Product Change Notification

March, 2012

Torque Improvement for Model 3851 & 3852 Single-Turn Panel Controls

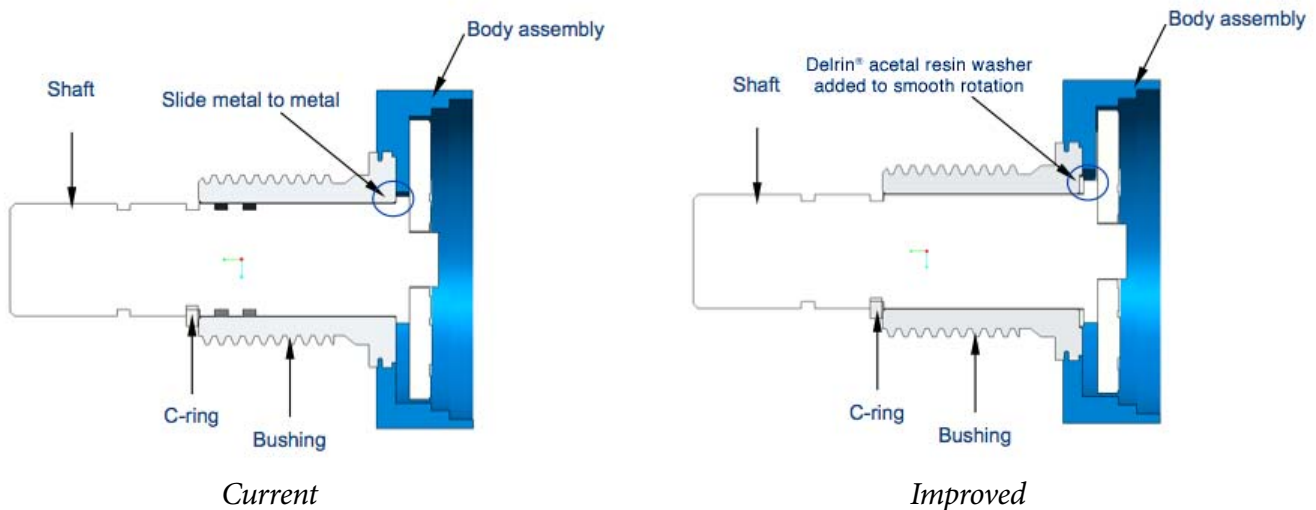
The design improvement involves the addition of a Delrin® acetal resin washer between the moving rotor and the rear side of the bushing. This results in a smoother feel and better consistency in rotational torque.
